Technical Service Bulletin

01 "Oil Level Sensor Oil Change Necessary" message appears - Instructions for reading oil level in 2.0 TDI vehicles

01 15 18 2040260/1 March 30, 2015.

Model(s)	Year	VIN Range	Vehicle-Specific Equipment
A3	2015	All	TDI clean diesel

Figure 1. Message briefly appears when car is started.

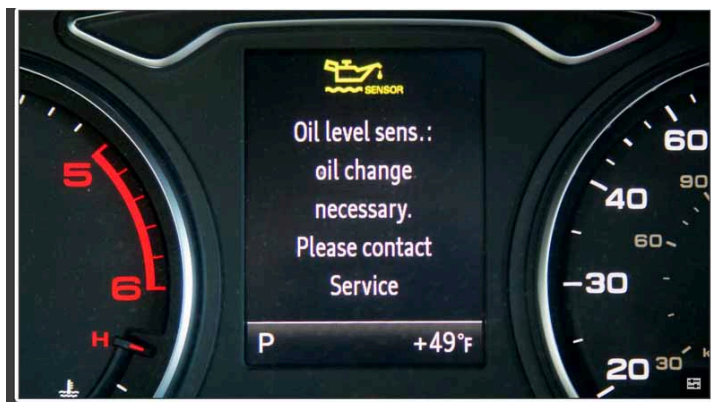
- The message "Oil level sens.: oil change necessary. Please contact Service" briefly appears in the information panel when the vehicle is started (Figure 1).
- The yellow oil level sensor remains illuminated in the information panel after the message disappears (Figure 2).
- The MIL is not illuminated and no DTCs related to the oil level sensor are stored.

If the vehicle was recently serviced or if the oil level was recently topped-off, correct the oil level and the message should disappear. If the oil level was not recently adjusted, verify that the level is correct and perform an oil change if necessary.

Figure 3. Revised dipstick for the Gen III EA288 2.0 TDI engine.

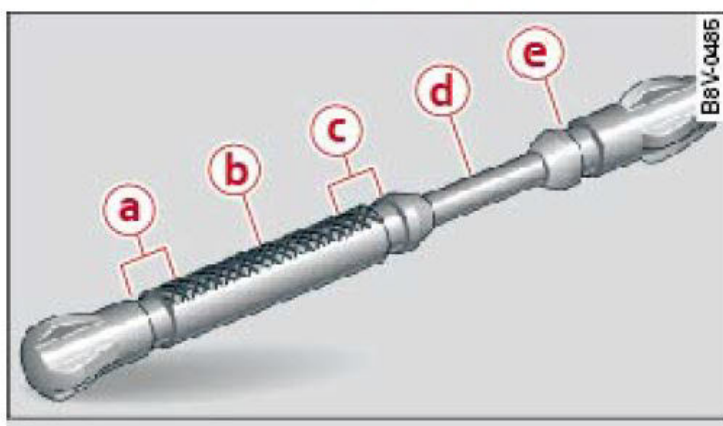
Tip: The Gen III EA288 2.0 TDI engine has a revised dipstick to accommodate biodiesel use. Use the following information and the image at right (Figure 3) to read the oil level:

- **Level a:** This is the oil minimum level. Oil must be added to reach level c.
- **Level b:** This is normal operating range. Oil can be added to reach level c.
- **Level c:** This is the oil refill maximum fill level and it is the target level for oil refills. Do not add oil beyond this level.
- **Level d:** This is the oil expansion region. Do not add any oil. It is possible for the oil level to rise above level c due to oil dilution, especially during heavy stop and go driving or during use of biodiesel. This is normal engine operation.
- **Level e:** This is the overfill zone. Do not fill oil to this level. Oil above this level causes the message to appear in the information panel and must be corrected. Do not replace engine oil level sensor if the warning message appears in the information panel and the oil level has reached or exceeded level e.
